## **ZONING CHANGE REVIEW SHEET**

CASE: C814-2018-0121 -- 218 South Lamar

TO: PUD

ADDRESS: 218 South Lamar Boulevard Southbound

4-Lane Divided, 60' Curb-to-Curb  
Back-of-Curb Condition F  
Barton Springs Road to Riverside Drive

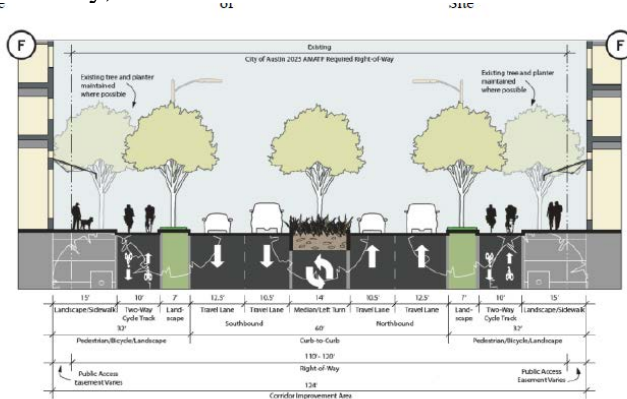
TR2. Include the below streetscape in the land use plan. Contact this reviewer for a more legible copy of it if necessary. This project is adjacent to a street that has been identified in Austin's Corridor Mobility Program (S Lamar). The sidewalk and bicycle facilities shall comply with the required cross-section at the time of the site plan application. The cross section that will be required is shown below. Find additional information about the Corridor Mobility Program here: <https://data.austintexas.gov/stories/s/Corridor-Mobility-Program/gukj-e8fh/>. Any proposed curb relocations on S Lamar requires coordination with the Corridor Planning Office and Bicycle Program. The cross section will include a 7' planting zone with street trees, a 10' two-way cycle track, and a 15' clear zone all behind curb. Additionally, a protected intersection will be required at Toomey, to be reviewed at the time of Site Plan.
